Aqueous Solutions (owner) AQS-MFG-FAB_UPW_TANK-GA_SIDE
FAB_UPW_TANK fabrication drawing GA_SIDE (AQS-PLAN-006 M3; g
Type: fabrication drawing (GA / nozzle orientation / part sheet) Rev b6ea8416 Issued
Created: flow graph pipeline Approved: not approved (study)
Sheet 1 of 1 AQS-DWG-001

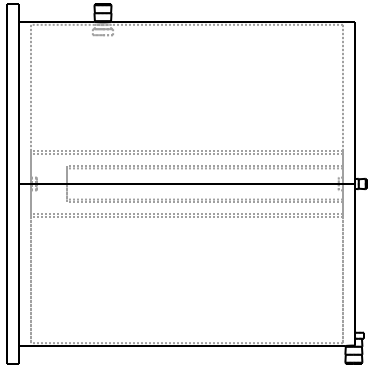
Graph revision AD - ga_side: The duty section 2 seven-day figure (0.4200 m3) exceeds the node box - named hold, nothing resized (W12)
Graph revision AD - ga_side: N2 outlet datum 600 clamped to 584.4 by the barb-radius rule; N4 vent flush at the top head (the 800 datum predates the box) -
Graph revision AD - ga_side: PE carried at the lib HDPE class row; the supplier TDS confirms the class at order (W1
